Technical Service Bulletin: TSB210078

Released Date: 21-Nov-2023

ReCon® Engines Without Electronic Control Modules (ECM)

Figure 1, Hang Tag Put in Place of the ECM.

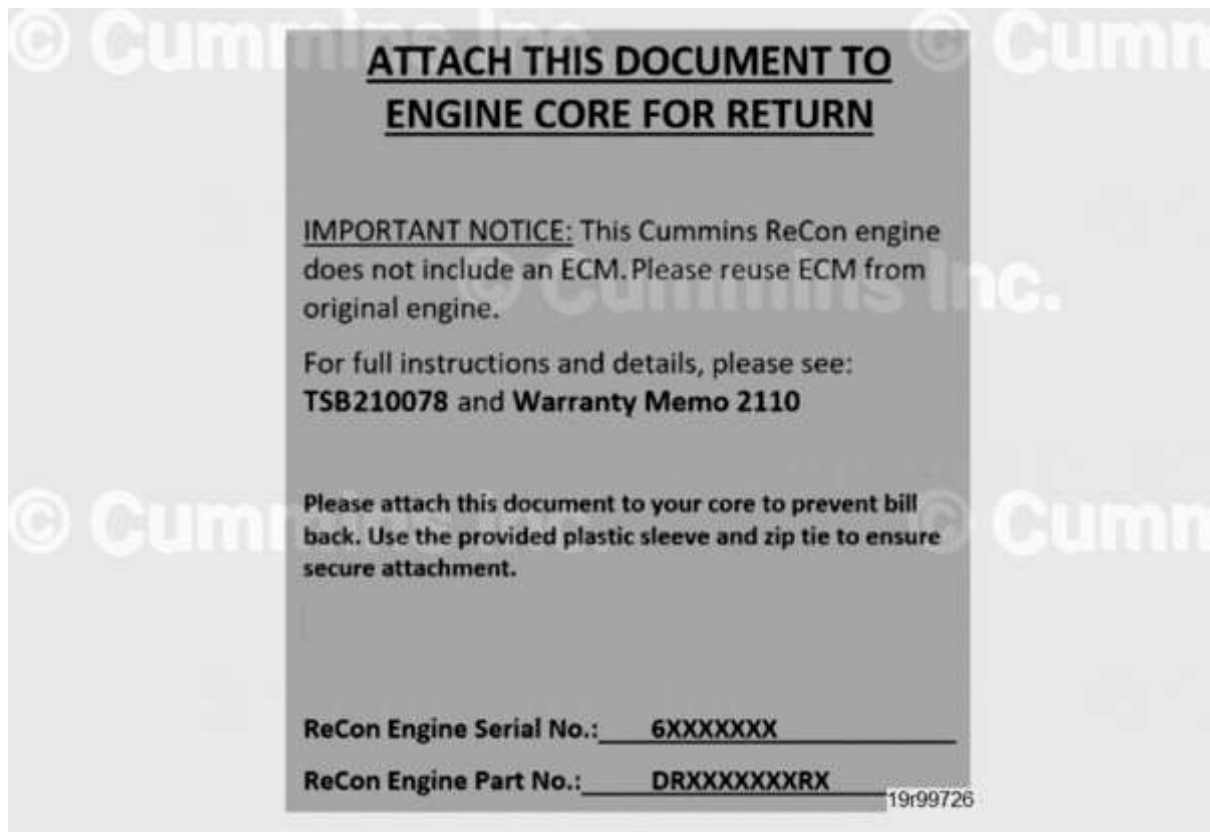
6. All affected ReCon® engines will arrive with a hang tag (see Figure 1 below) in place of the ECM. This tag **must** be attached to the core engine prior to being returned.
